<b>APPLICATION NO</b>	<b>PA/2021/891</b>
<b>APPLICANT</b>	Mr G Clements
<b>DEVELOPMENT</b>	Planning permission to erect 9 dwellings with landscaping and access
<b>LOCATION</b>	Land rear of 9-11 Torksey Street, Kirton in Lindsey, DN21 4PW
<b>PARISH</b>	Kirton in Lindsey
<b>WARD</b>	Ridge
<b>CASE OFFICER</b>	Emmanuel Hiamey
<b>SUMMARY RECOMMENDATION</b>	<b>Refuse permission</b>
<b>REASONS FOR REFERENCE TO COMMITTEE</b>	Member 'call in' (Cllr Neil Poole – significant public interest) Objection by Kirton in Lindsey Town Council

# PA/2021/891 Proposed layout (not to scale)

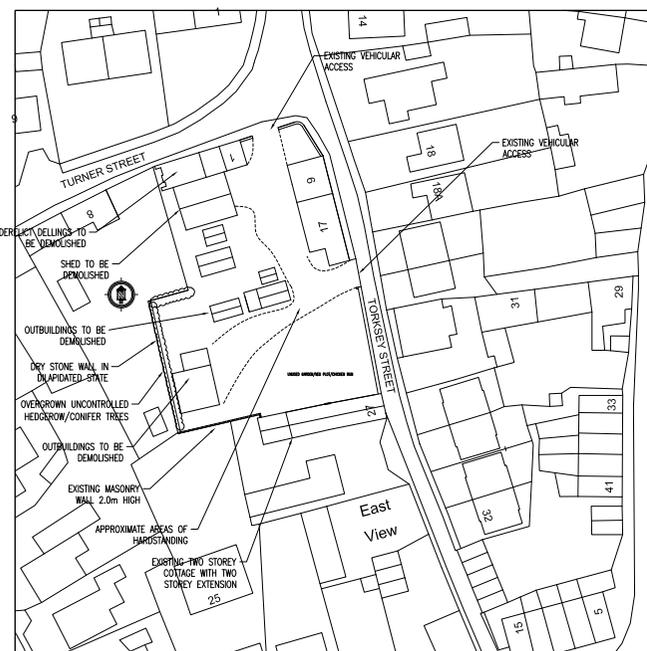
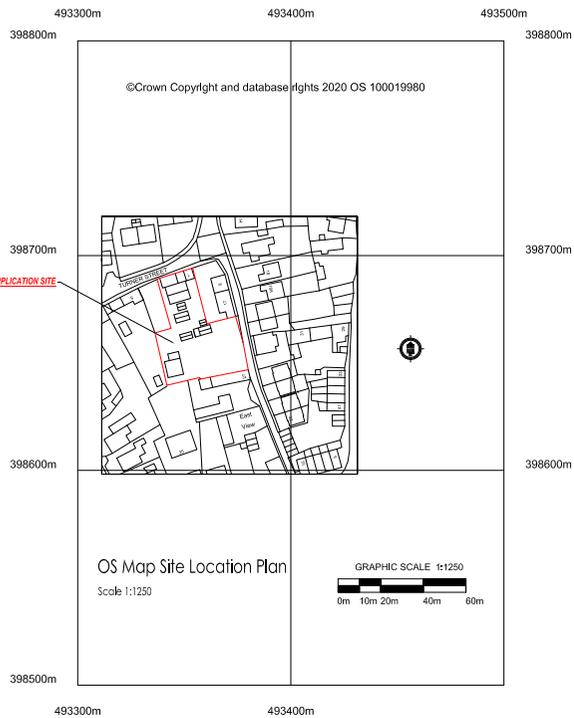
Regarding the impact of the proposal on the surrounding area, the dwellings proposed fronting Turner Street (units 1–3) and Torksey Street (units 4–6) would be prominent in the street, which has a mix of different dwelling types and designs, including two-storey terraced dwellings.

Having given due regard to the character of the site in the context of the surrounding area, it is judged that the relationship between the site and the existing built form, is not suitable because the site is infill housing development and would result in a higher-density residential scheme (i.e. the ratio of land area and number of dwellings) in a relatively low to medium density residential area, where the surrounding residential units have either large or modest gardens.

Also, this high-density residential scheme would result in a cramped development with dwelling units associated with small gardens.

Overall, the siting and layout of the site is not acceptable in the context of the character and appearance of the immediate area and would impact negatively on the character of the conservation area.

Having regard to the effect of the development on privacy levels, it is worth noting that Units 7–9 would face Units 1–3. The separation distance between Units 1–3 and Units 7–9 is approximately 10m. Where windows serving accommodation in a dwelling face another dwelling, the development must demonstrate that the separation distances would ensure that privacy levels are protected and reflect the highest possible standards of design. In this case, the separation distance of 10m is insufficient to protect the privacy of the properties.

The first-floor windows of Units 7–9 would overlook the amenity areas of Units 1–3 (private garden).

Generally the development would not accord with policy in terms of ensuring that the privacy/amenities of Units 1–3 are safeguarded as part of the proposed development. The design statement does not demonstrate how residential privacy would be maintained.

Crated storage within plots 1, 2 and 3 serving all other plots. The use of connected private surface water drainage systems which are reliant on one outfall/property owner is not permitted unless a robust adoption and maintenance plan is produced. The reliance on one owner to maintain a drainage system, that if not maintained can cause civil and legal disputes moving forward with several neighbouring properties. This is an approach that other local authorities are adopting. There is no reason why each property cannot have its own individual surface water drainage outfall. This is not a good solution unless it is a public sewer and adopted by the water company.'
